**Consultation Response from Mike Hibbert,
KC Waste Strategy(Refuse & Recycling)**

2024/92302 Huddersfield Bus Station, Upperhead Row, Huddersfield, HD1 2JN

Responding Ref: WPS 24-075

Bin store design drawing HBS-ECS-Z0-SL-DR-L-00004-P02 - Bin Store dated 25.06.24 Shows the design, specification and screening of the bin store. These proposals are acceptable.

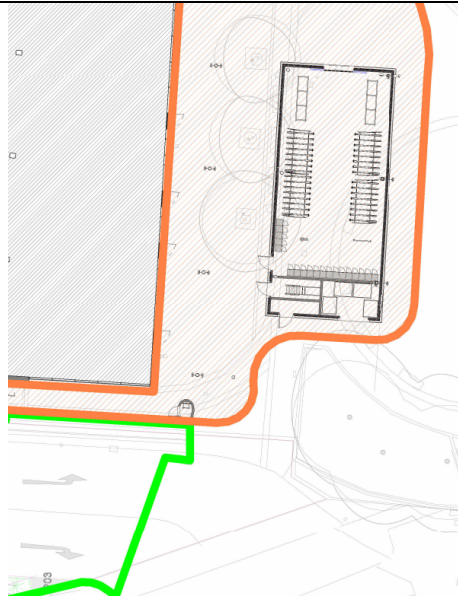
GA Floor Plan (Overall) Drawing Number HBS-AHR-XX-00-D-A-20-001 S2 Rev P4 dated 25/10/24 shows the location and orientation of the proposed main bin store. The dimensions are acceptable and the gates at either end enable access to both the Front-End Loader (FEL) skip and wheeliebins. Vehicular access for collection vehicles by shown by the hatched area in yellow.

A bin store is shown at the front of the bin station within the cycle store on GA Floor Plan (Overall) HBS-AHR-XX-00-D-A-20-001 S2 Rev P4 dated 25/10/2024.

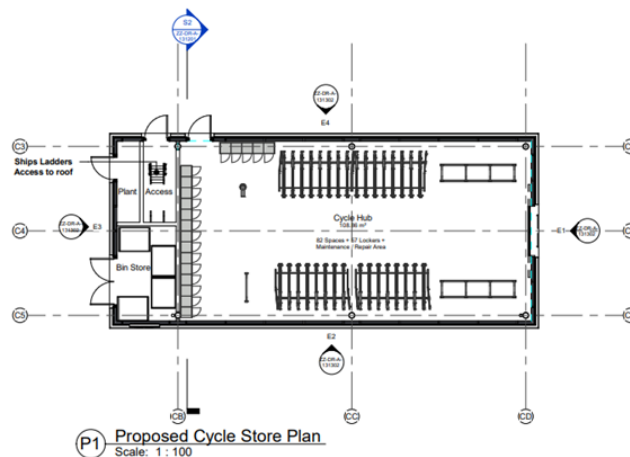
This bin store is also detailed on Page 31 of the Huddersfield Bus Station Design & Access Statement 2023.00190.000 Kirklees Council Planning Authority dated June 2024

- **It is not clear from the plan for documentation what types/ capacity of wheeliebins will be used, the intended wastes to be stored and where the Bin Collection Point (BCP) with access for a Refuse Collection Vehicle (RCV) will be located.**
- The overall proposal should incorporate storage for specific waste arisings such as canteen/ food waste, baby changing/ sanitary waste, litter bins, vehicle washing effluent and maintenance wastes if required.
- There should be provision of litters bins and landscaping design layout must consider suitability for use of mechanical street sweeping equipment.
- It is not clear from the application if waste generated from tenants within the wider bus station building e.g. retail premises will be stored within the waste compound.
